Addendum # 2

Bid Opportunity: 25-7639-RFT - Alpine Public School HVAC Upgrade

RE: Alpine Public School – HVAC Upgrade
Kitchener, ON

ADDENDUM 01

GROUND FLOOR
PLAN RENOVATION

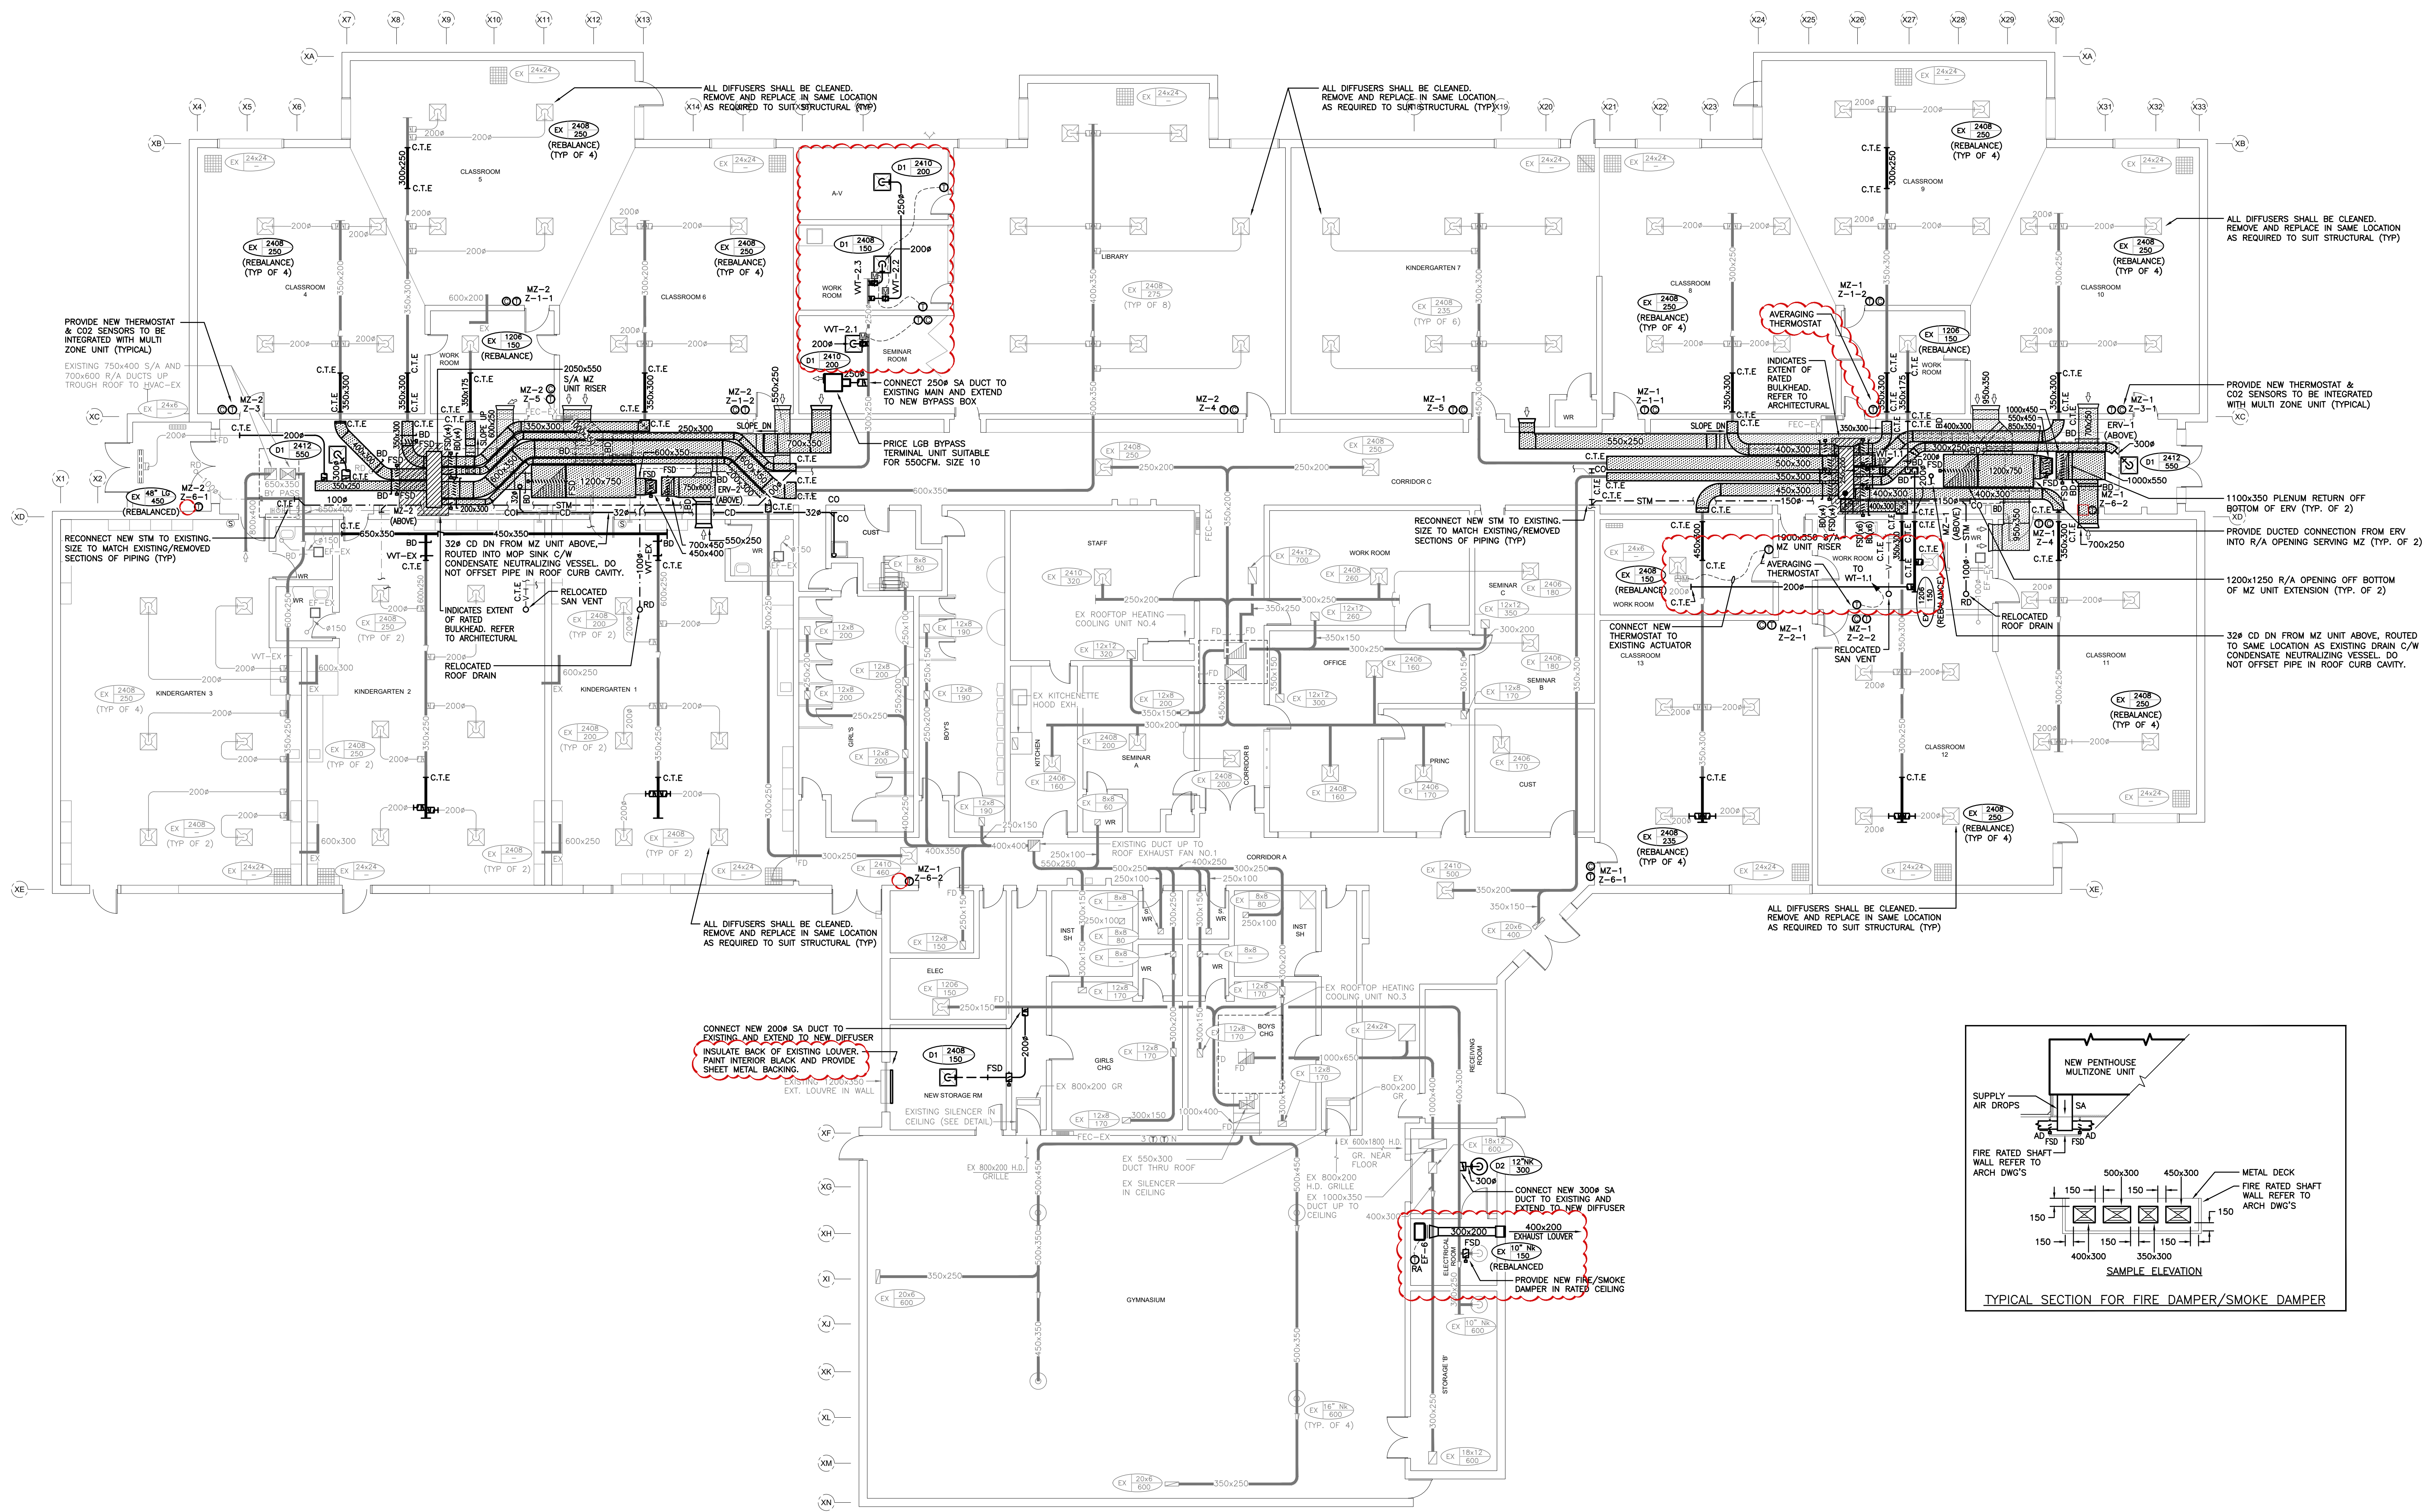
Item 4**4.0 Reference Attached Reissued Drawings M201, M202, M301, and M302**

- .1 Revise ductwork in Seminar Room, Work Room, and AV Room as shown.
- .2 Provide averaging thermostat for work rooms as shown.
- .3 Revise electrical room and storage room louvre as shown.
